Date: 01/05/2015

Decision to approve the revised volume requirement, procurement and operational methodologies proposed by National Grid Electricity Transmission plc associated with the procurement and use of the Supplemental Balancing Reserve and Demand Side Balancing Reserve

Figure 1: NGET proposed load factor weighting

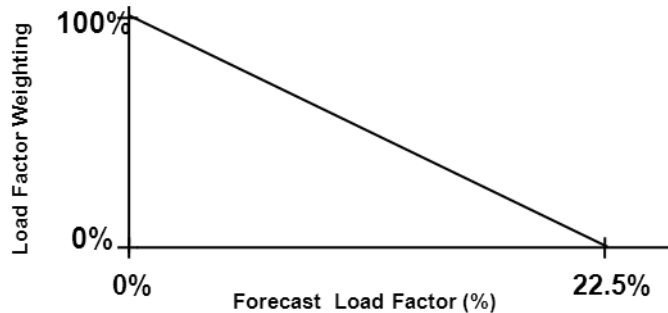
We support NGET's proposal to refine the methodology to ensure that the services procured provide value for money to consumers. We note that there is no perfect measure of additionality, and hence there will always be limitations with any proxy used.

Following NGET's submission, we have been contacted by a few generators both opposing and supporting NGET's selection of historic load factor as a proxy for unavailability to the market. Those opposing it noted that closure decisions can be based on a variety of factors, for example investment and maintenance decisions. In addition, since this uses historic data, they note that it does not capture the potential changes to plant profitability due to changes to fuel and carbon prices.

Following our analysis, we agree with NGET that that despite its limitations, using historic load factor is a reasonable, transparent, and objective proxy for market unavailability. It is **reasonable** because it is representative of decisions we have seen in the market. Since 2012, NGET analysis indicates that the weighted average load factor of the CCGTs that have closed or mothballed was 9.2%.⁶ This is well within the range NGET proposes to capture in its weighting. It is **transparent**, as the information is accessible to all market participants. As such, parties are able to calculate their load factor as well as its competitors. It is **objective** as it does not depend on NGET's judgement and expectation on the future outlook. In addition, parties cannot amend their historic load factor, preventing gaming.

Hence, while we recognise the limitations of using load factor as a proxy of power station unavailability, we are confident that this would be an improvement from the current methodology as it would help ensure consumers only pay for services that add value to them, and we think it is a proportionate way to better value additionality.
